MEMORANDUM

**Subject: Review of Contaminant Conditions
CSXT Bramlette Road Former Manufactured Gas Plant (MGP)
Greenville, South Carolina
Project No.: 019-12**

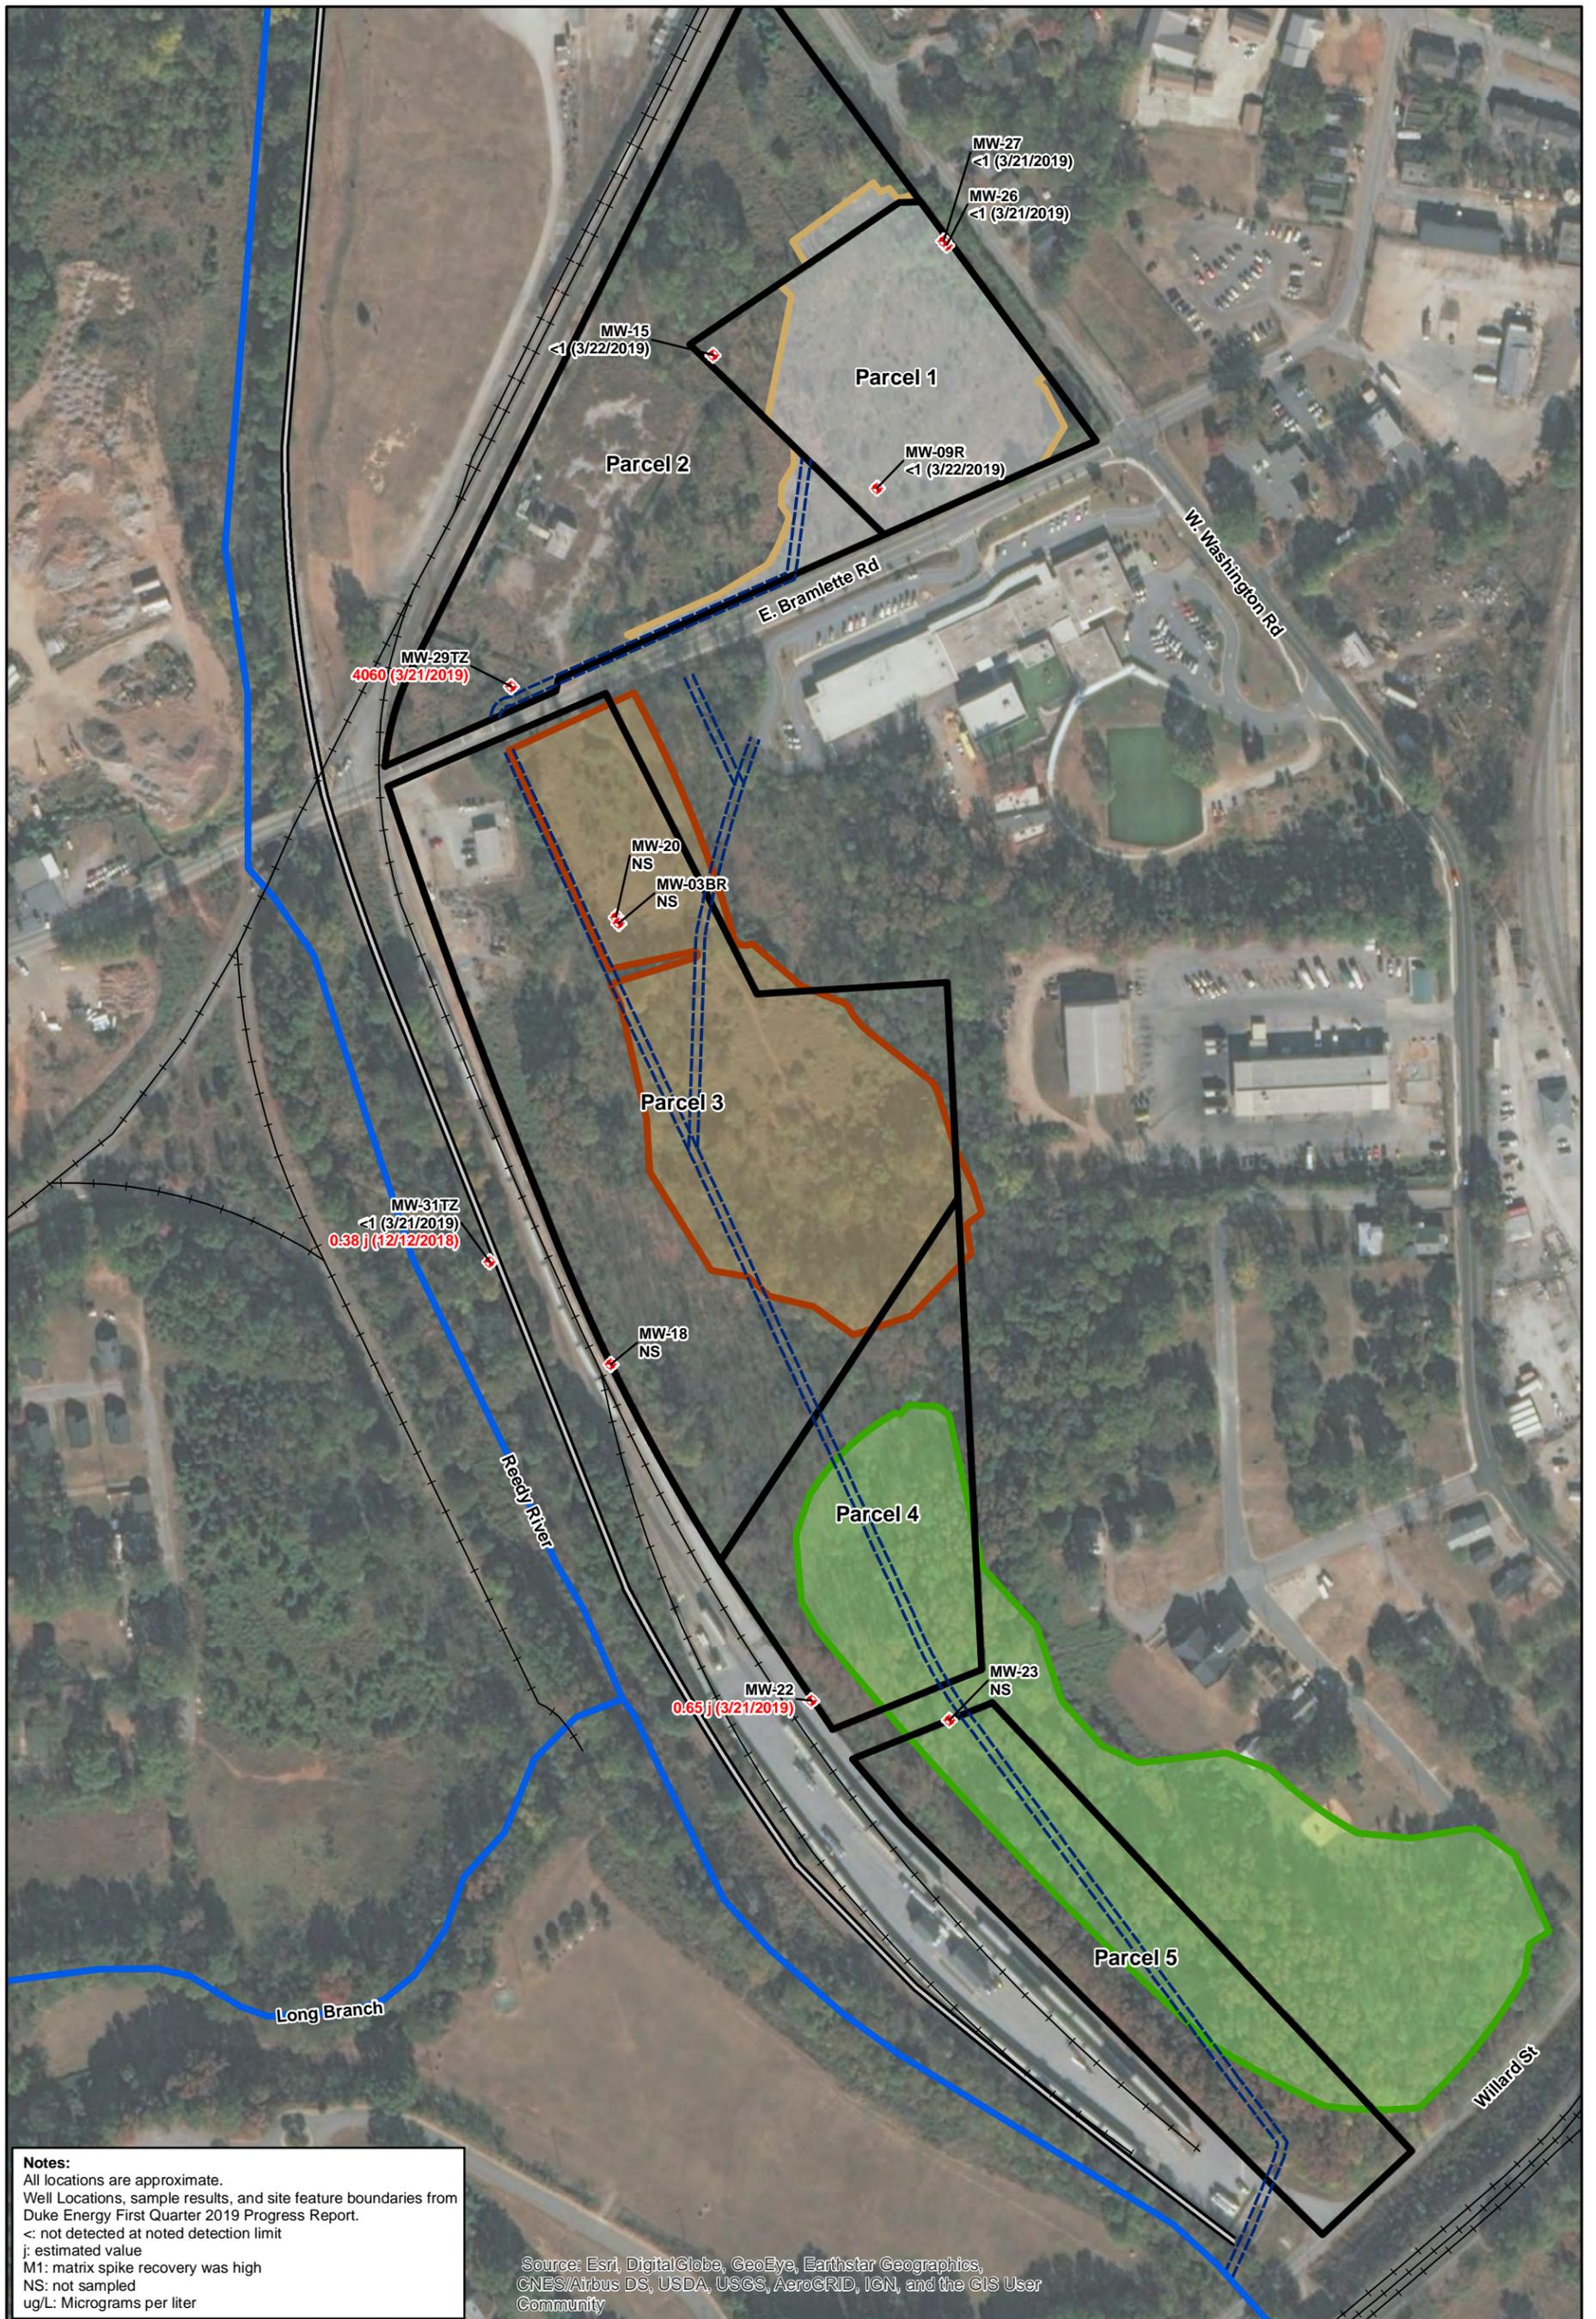
Neither the maximum depth nor the down-gradient extent of benzene and naphthalene (as indicator compounds for VOC and SVOC contamination) contamination in groundwater have been delineated (**Figures 4 through 7**). As mentioned above, benzene and naphthalene were detected at concentrations of 1,920 ug/L and 4,060 ug/L, respectively, in a groundwater sample taken from MW-29TZ. MW-29TZ is located approximately 500 feet down-gradient of the former MGP. No monitoring wells have been installed beyond MW-29TZ north of East Bramlette Road in the down-gradient direction (**Figure 1**).
